Addendum to:

ARBORIST REPORT-
Tree Resource Evaluation & Project Impact Analysis

Peace Church
900 High Street
Santa Cruz, CA
APN: 001-022-40

9/25/2022
Addendum Date 12/13/2025

Sheet T1

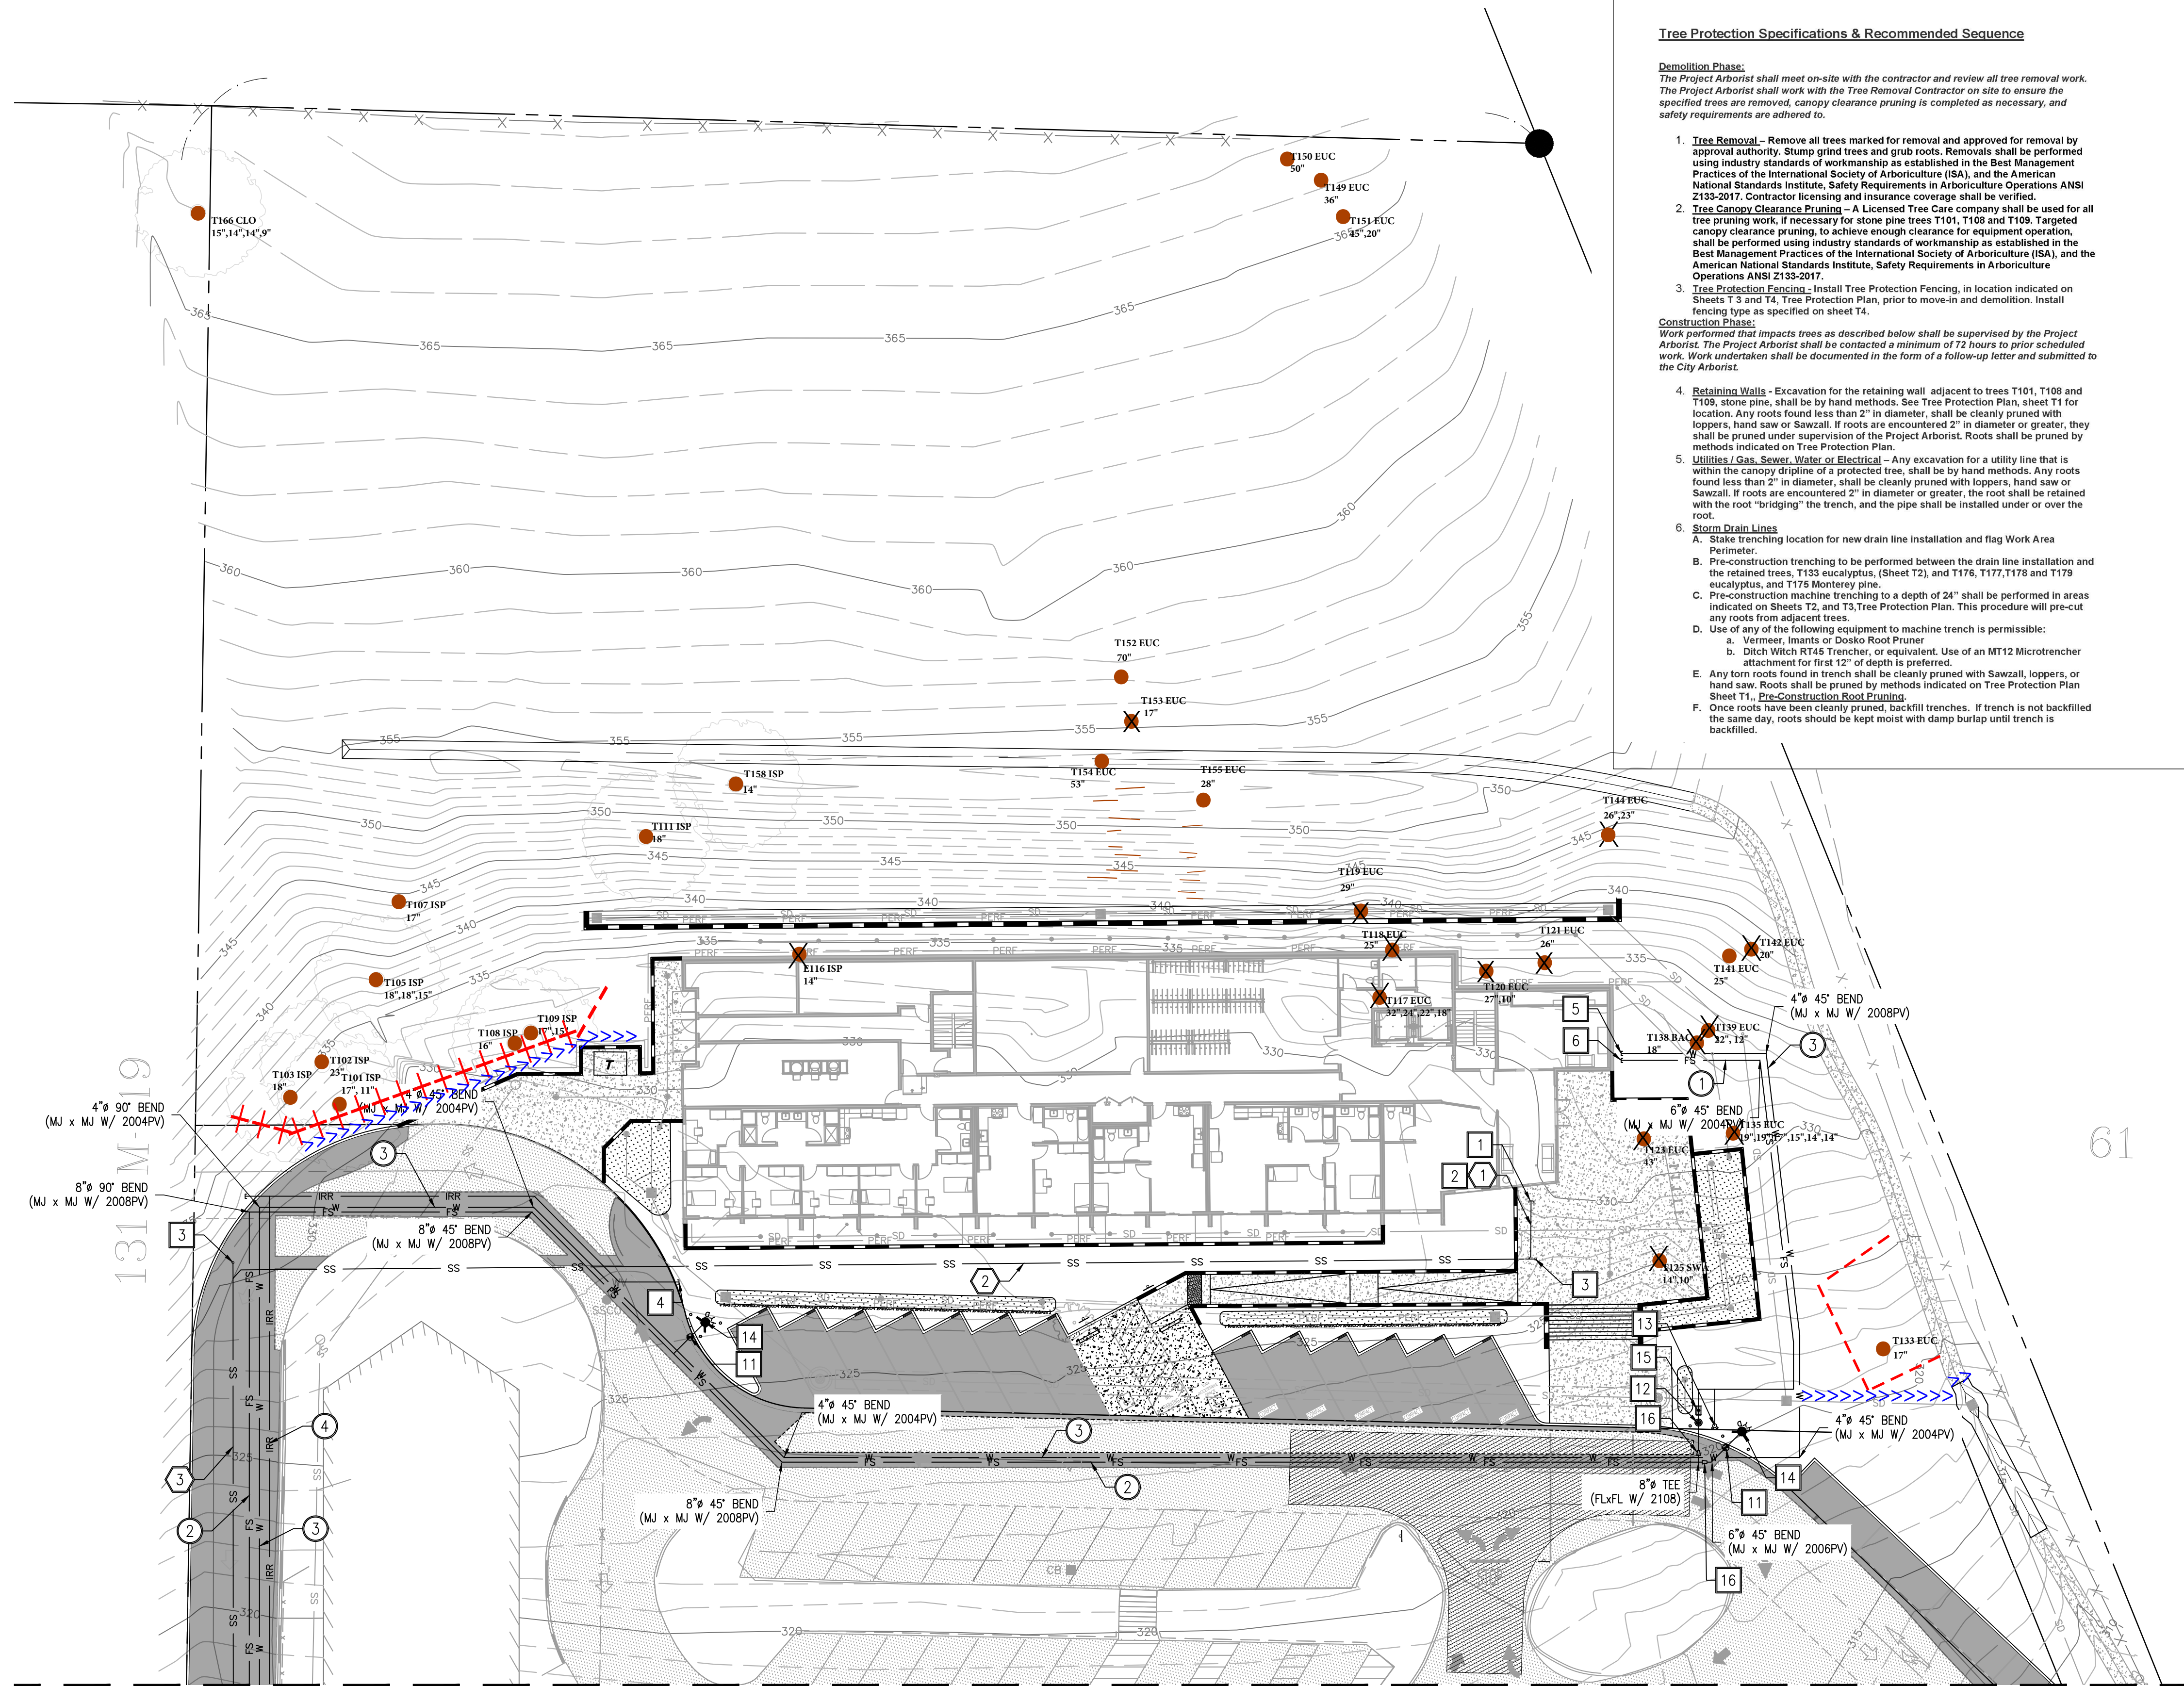
Table #4, Tree Disposition Categories – *Heritage Trees*, from the arborist report dated 9/25/2022, has been updated, and is contained in this addendum. The Tree Assessment Chart spreadsheet, and Sheet T2, Tree Protection Plan, (Heritage Tree Removal Plan from 9/22 arborist report), was also updated to reflect the revised anticipated construction impacts, and tree disposition. An additional Sheet T3, Tree Protection Plan has been added to the report.

On 12/4/2025, I made a site visit to survey the six *Heritage trees*, (trees T174 to T179), and the data from that survey are included in the updated Tree Assessment Chart, Appendix A, page 8.

Sheet T2
of 3 sheets

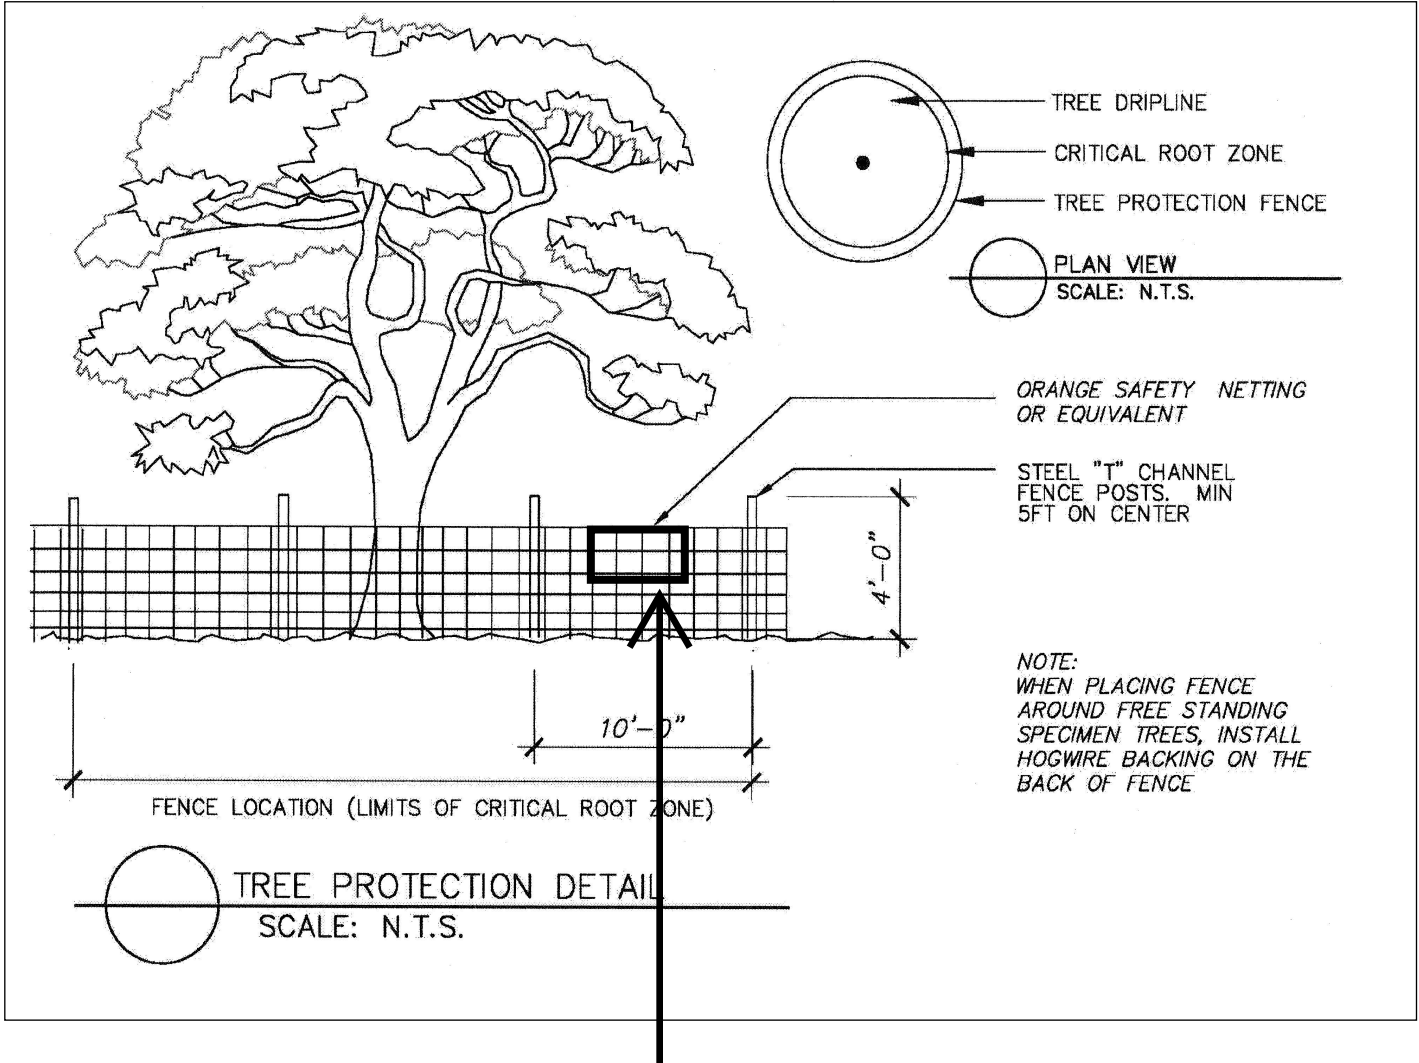
- Storm Drain Lines**
 - Stake trenching location for new drain line installation and flag Work Area Perimeter.
 - Pre-construction trenching to be performed between the drain line installation and the retained trees, T133 eucalyptus, (Sheet T2), and T176, T177, T178 and T179 eucalyptus, and T175 Monterey pine.

- Pre-construction machine trenching to a depth of 24" shall be performed in areas indicated on Sheets T2, and T3, Tree Protection Plan. This procedure will pre-cut any roots from adjacent trees.
